STATE OF WASHINGTON
DEPARTMENT OF ECOLOGY

Re: Review of March 1, 2017 Draft for Ecology Review Feasibility Study Report

- **Site Name:** Sound Mattress and Felt Company Site (Site)
- **Site Address:** 1940 East 11th Street, Tacoma, WA (Property)
- **Facility/Site No.:** 1232087
- **Cleanup Site ID No.:** 1615
- **VCP Project No.:** SW0857

Figure 8
 Site Extent

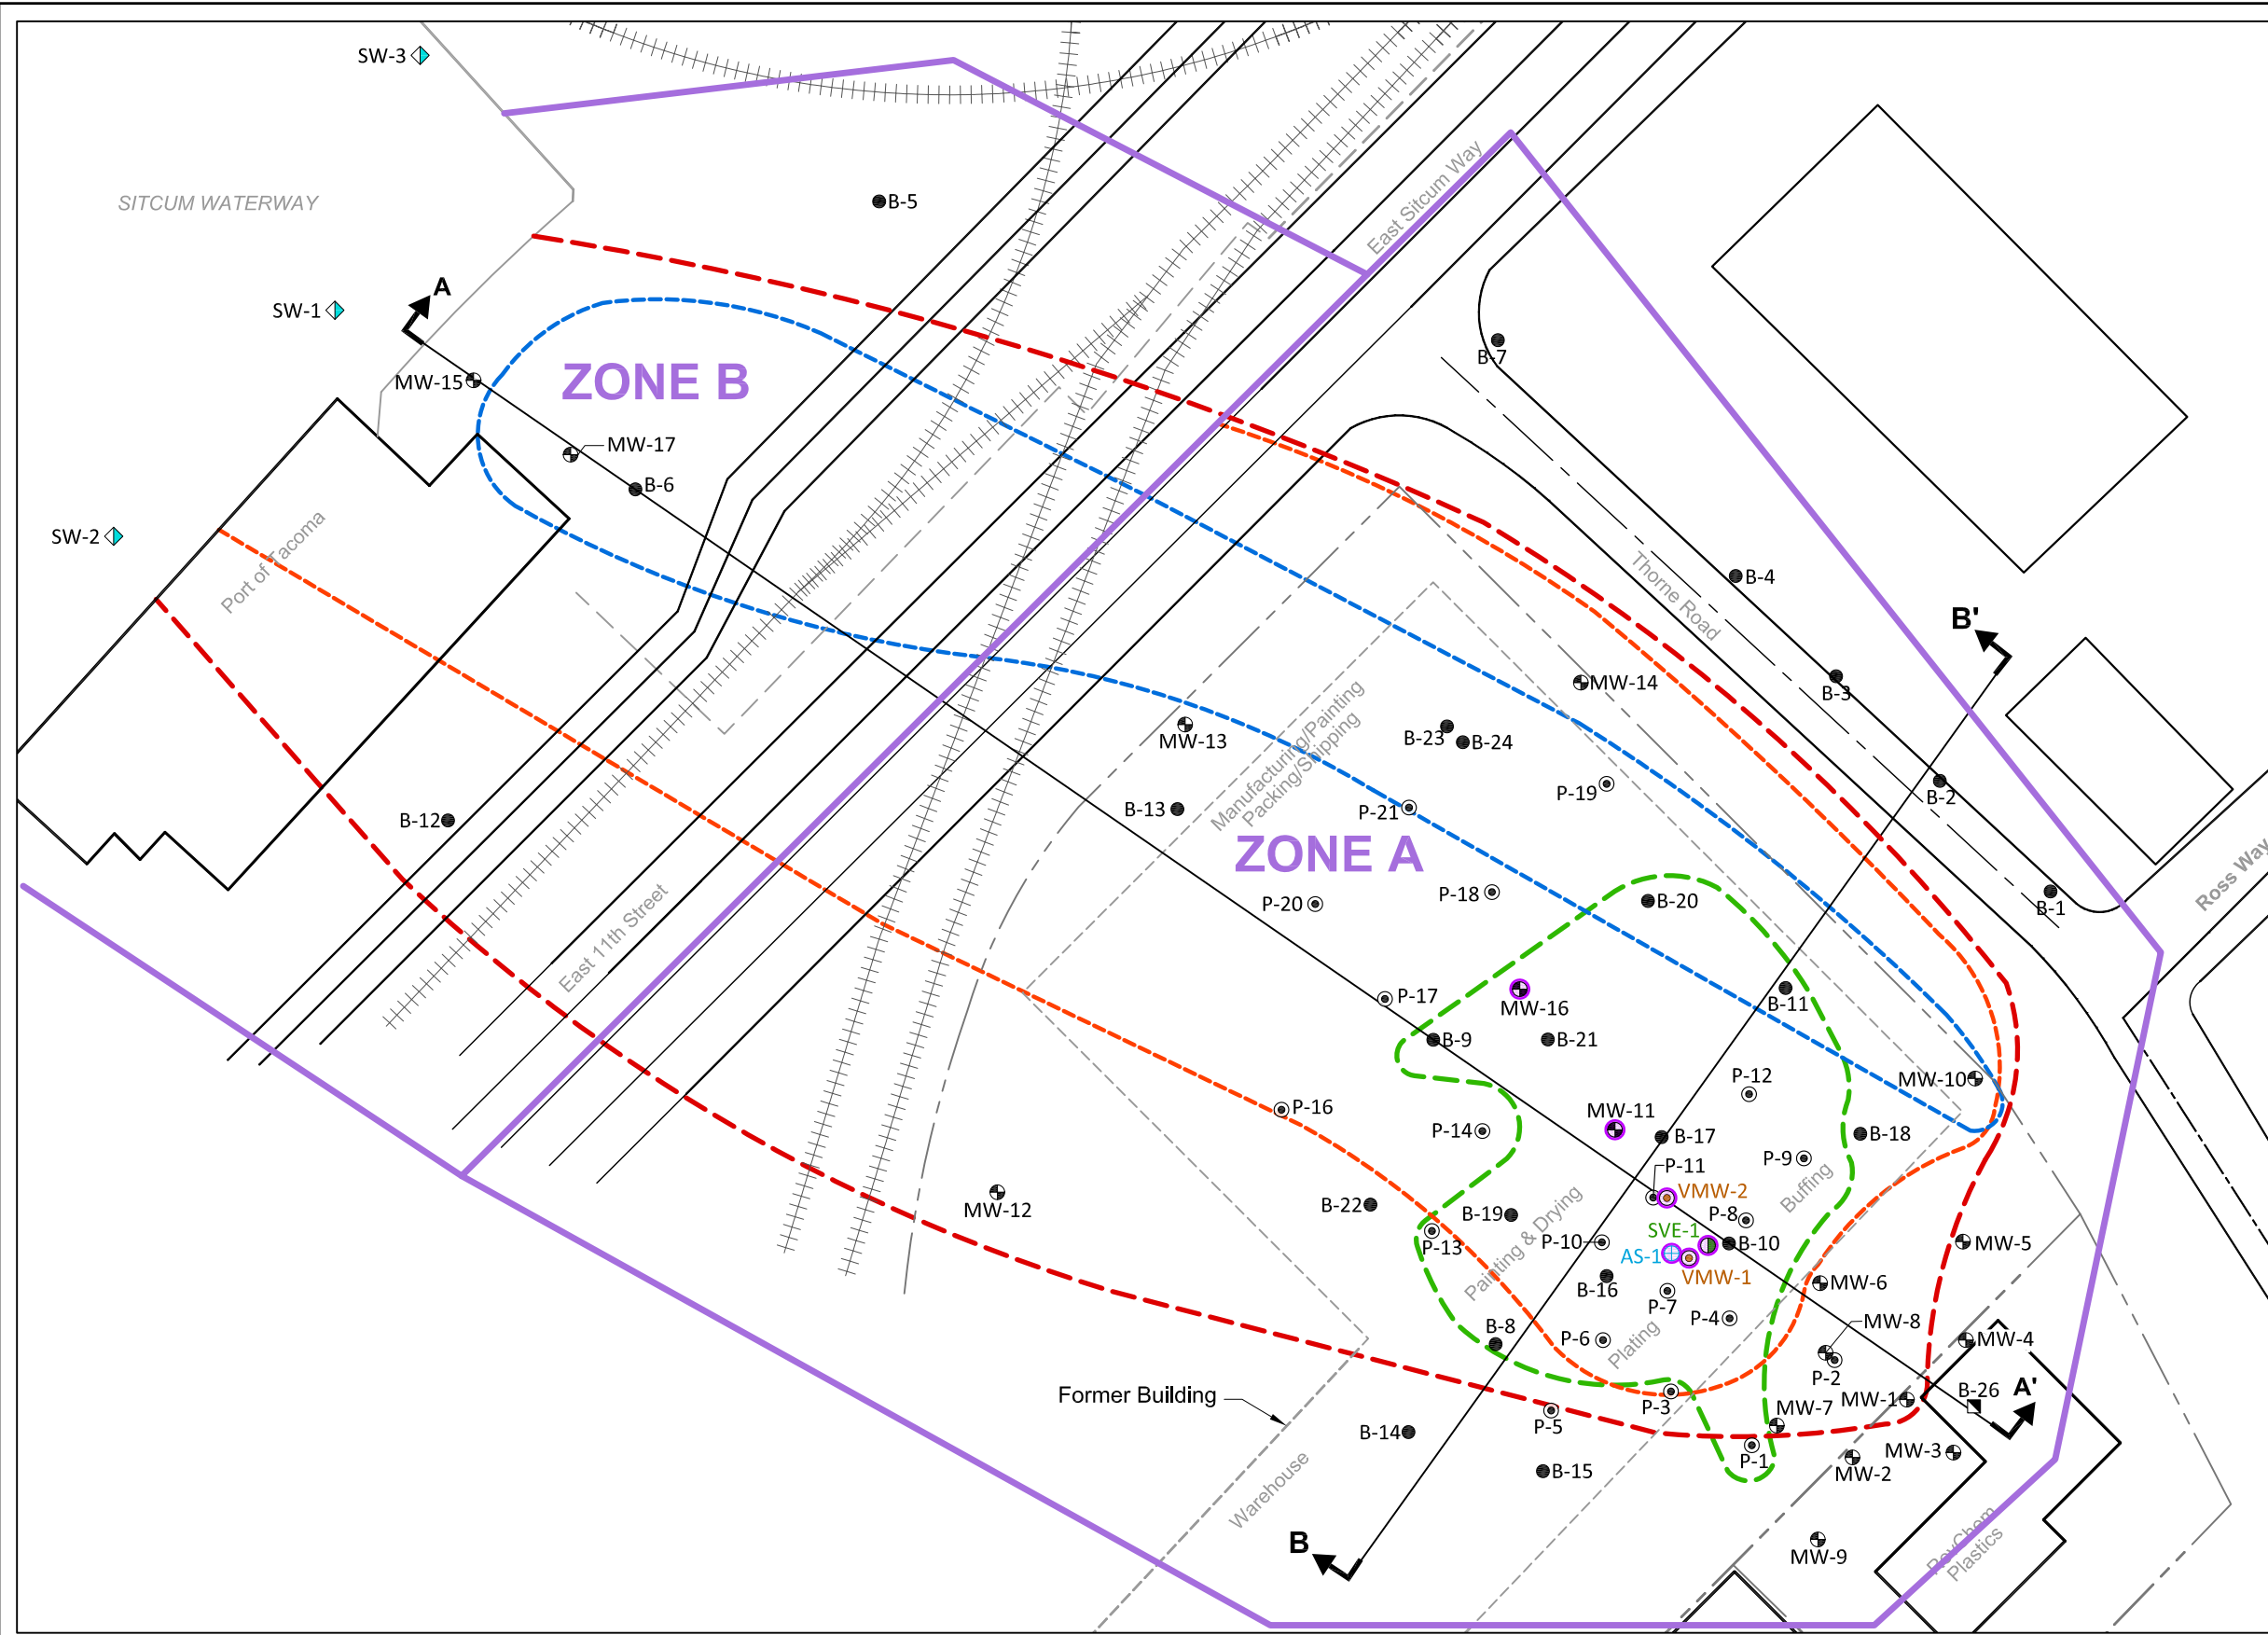
- 1.1. Review of both the 2017 Draft FS and 2010 Data Gap Report reveal conflicting statements and presentations regarding potential CVOC-impacts to the Sitcum Waterway. For example, Figure 8 in the 2017 Draft FS (attached) depicts the “*estimated extent of groundwater with CVOC COC concentrations exceeding applicable Site Specific Cleanup Levels*” as extending into the Sitcum Waterway. Conversely, Section 2.3 of the 2017 Draft FS states that unspecified “*empirical data*” indicates that both PCE and TCE in groundwater do “*not currently and is unlikely in the future to ever ‘reach’ surface water*”. Additionally, Section 4.2 of the 2010 Data Gap Report included the statement that the “*groundwater sample from well MW-15 indicates concentrations of cis-1,2-DCE and VC in groundwater are likely impacting surface water in the Sitcum Waterway*” (Ecology’s emphasis). As indicated above, no specificity was provided regarding the “empirical data” referenced as supporting the conclusion that CVOCs have not impacted the Sitcum Waterway. Ecology concurs with the assessment provided in the 2010 Data Gap Report indicating that CVOCs have likely reached surface water within the Sitcum Waterway.

While Ecology acknowledges that deployment of passive diffusion bag (PDB) samplers during October of 2014 did not detect concentrations of CVOCs above their respective reporting limits in surface water within the Sitcum Waterway, an evaluation of sediment at the associated groundwater/surface-water interface has not been performed, thus representing a significant data gap in terms of Site characterization.

To resolve the uncertainties regarding whether CVOCs have reached the Sitcum Waterway and whether these constituents are present within the groundwater-surface water interface, please provide a proposal to further evaluate sediment within the Sitcum Waterway. Ecology acknowledges that the presence of rip-rap along the submerged margins of the Sitcum Waterway present challenging physical conditions, however, further evaluation of submerged media beneath this area of the Site is warranted. Ecology recommends evaluating the use of push-probe or angled-boring techniques to access sediment immediately beneath the rip-rap. The presence of seeps beneath the rip rap cover during low tidal stages should also be evaluated in this area of the Site. If observed, it is further recommended that seep samples be collected for CVOC analysis.
